Department of Water Resources

Date: December 31, 2019

Subject: Response to expert report in the matter of designating the Eastern Snake Plain Aquifer Ground Water Management Area, Docket No. AA-GWMA-2016-001

Water table contour map from Haskett (1972)

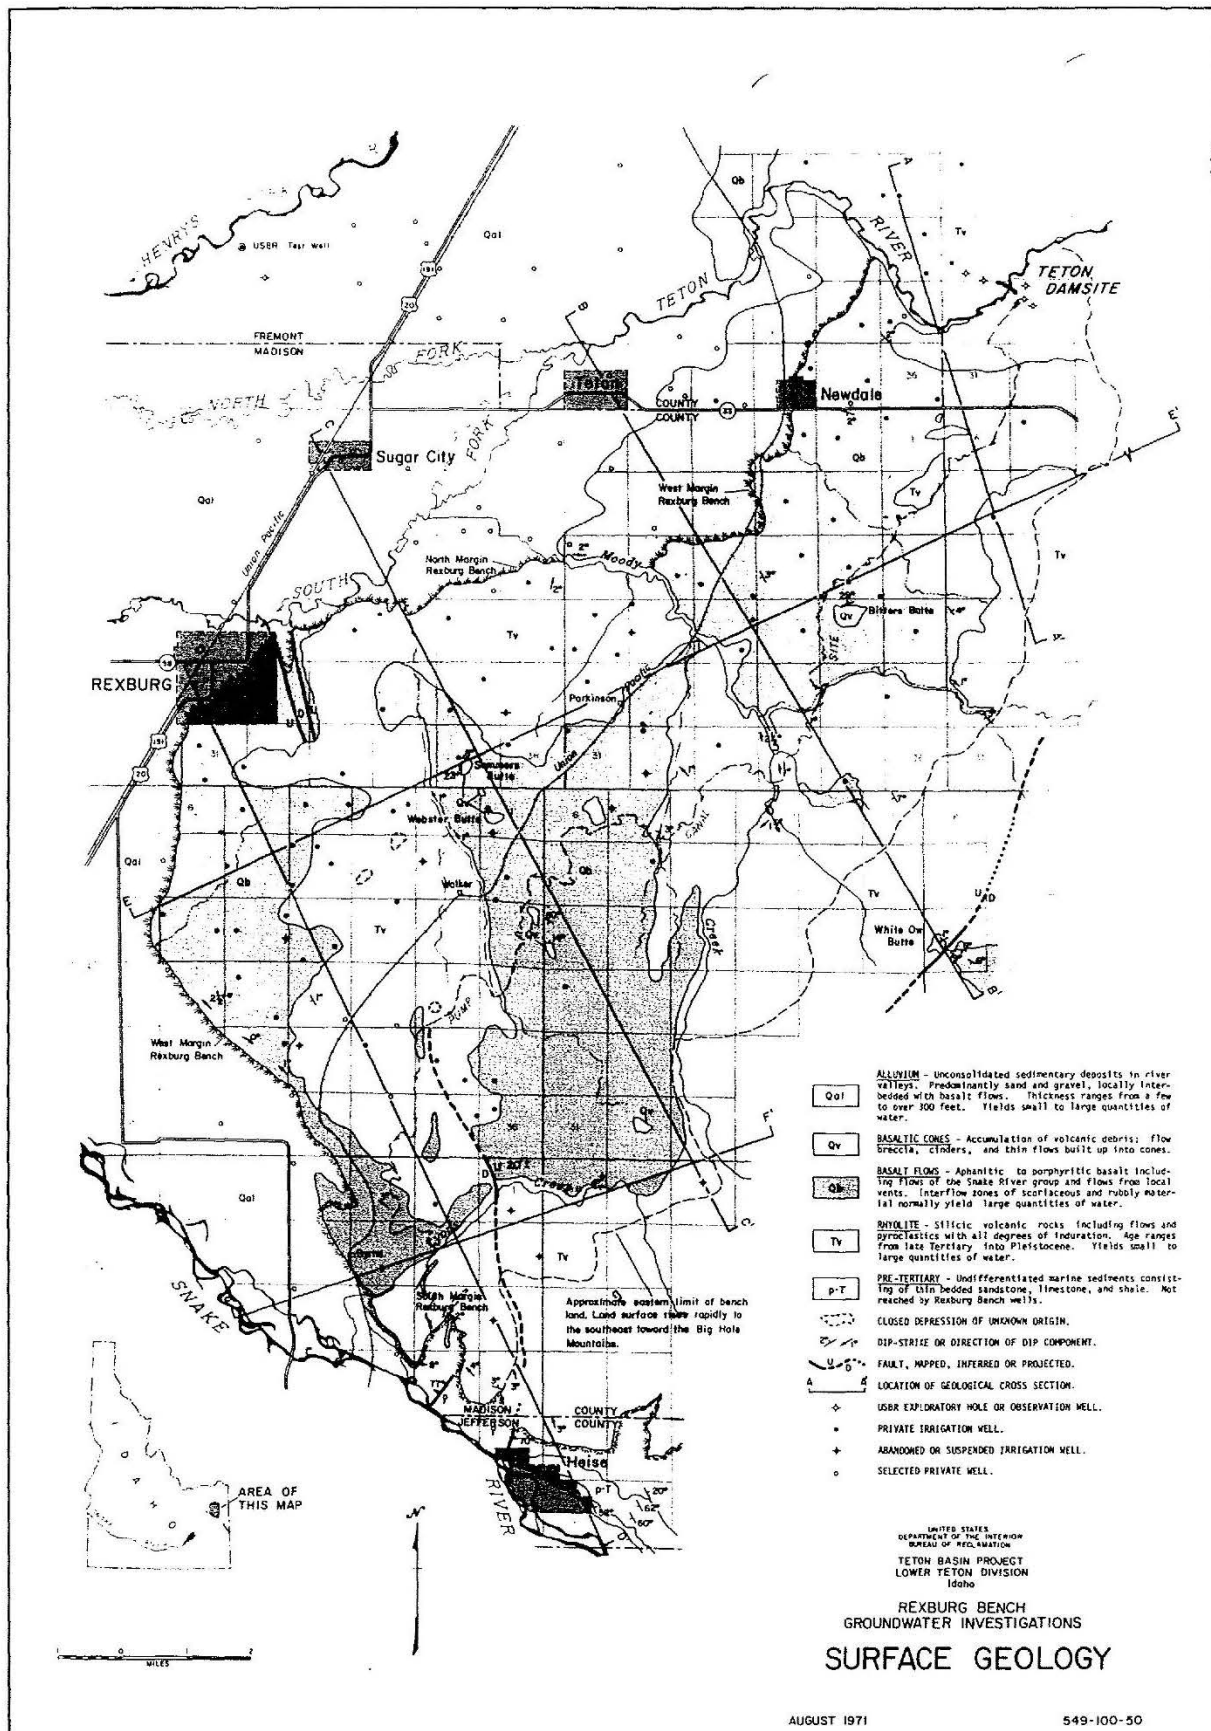
Haskett presented water level data collected from wells on the Rexburg Bench by the U.S. Geological Survey, Bureau of Reclamation, pump contractors, and well drillers. Contor's static water level analysis is inconsistent with water level information presented by Haskett. Attachment A includes Haskett's water level contour map with water levels from the fall of 1970. Attachment B includes cross-sections from Haskett's report showing water levels and Haskett's interpretation of the perched and regional water table. Perched groundwater occurs locally where clay layers are present. When recharge exceeds pumping in perched aquifers, water will drain to the regional water table at the margins of the clay layers. Haskett shows the regional water table extending from beneath the Rexburg Bench to adjoining areas underlying the Teton River and Eastern Snake Plain. Haskett's contour map shows groundwater flowing from underneath the Eastern Snake Plain to underneath the Rexburg Bench along the northern and southern margins of the bench, and from underneath the Rexburg Bench to underneath the Eastern Snake Plain along the western margin of the bench.

Excerpt from Whitehead (1992) geologic map

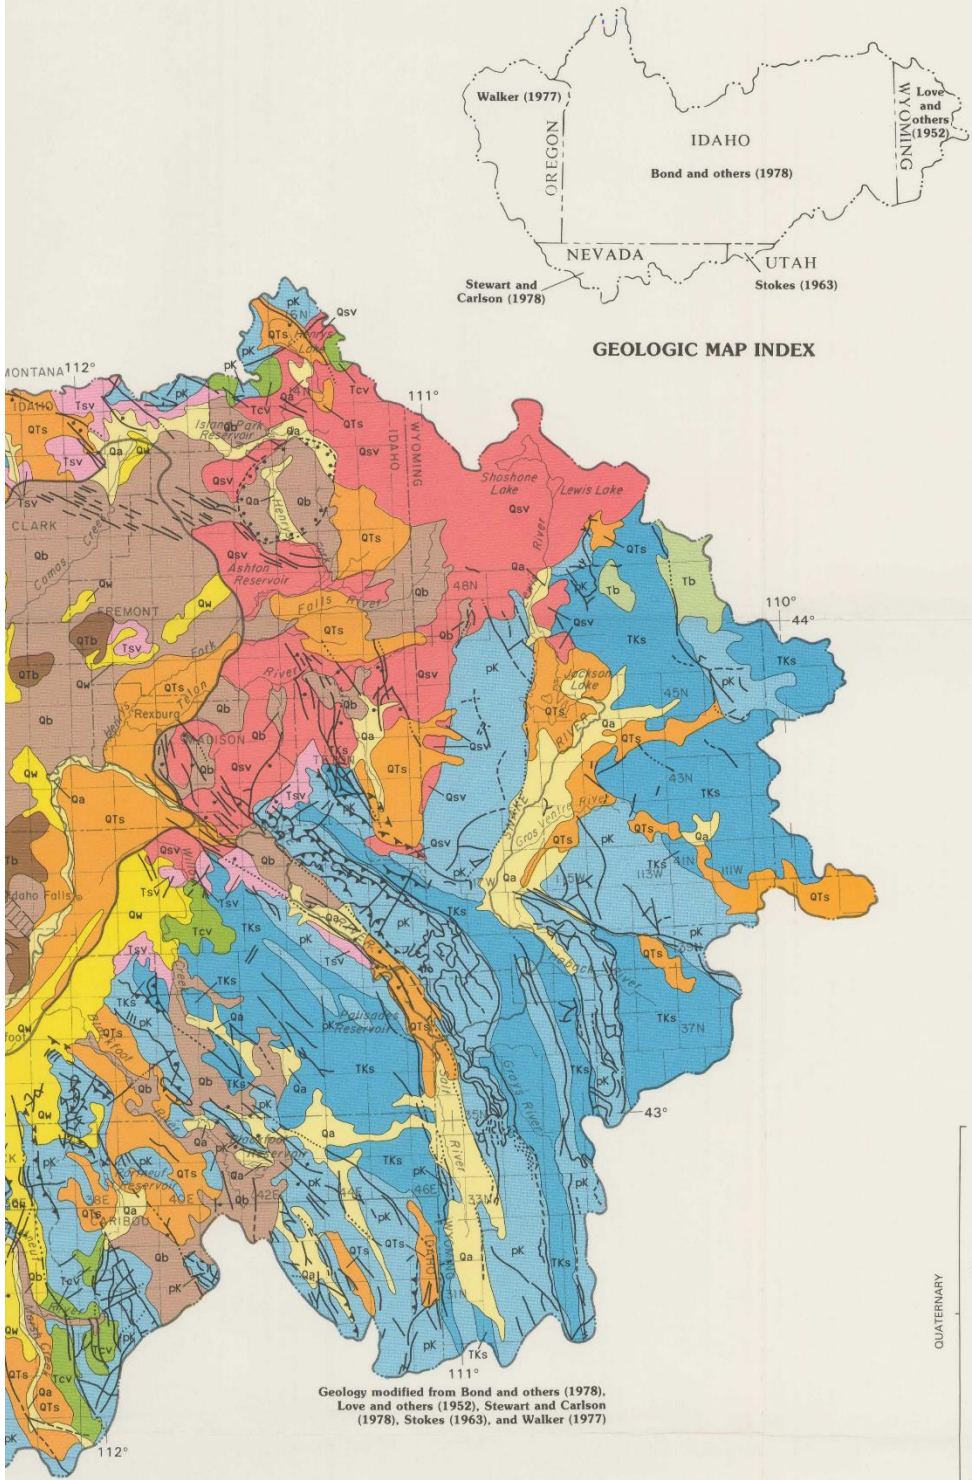
Attachment C shows the geologic map from the RASA report (Whitehead, 1992, plate 2). In this map, the Rexburg Bench is mapped as Quaternary Basalt of the Snake River Group (Qb) and Quaternary silicic and volcanic rocks (Qsv) of the Yellowstone Group and Plateau Rhyolite. Since the RASA boundary in the vicinity of the Rexburg Bench is not at a mapped land-surface contact between Quaternary and Tertiary or older rocks, and younger rocks extend beyond the boundary, Whitehead’s description of an “arbitrary boundary selected on the basis of topographic relief” appears to be applicable to the RASA boundary in this area. I found no indication in the RASA reports that the delineation of the RASA boundary was intended to delineate the entirety of a groundwater basin.
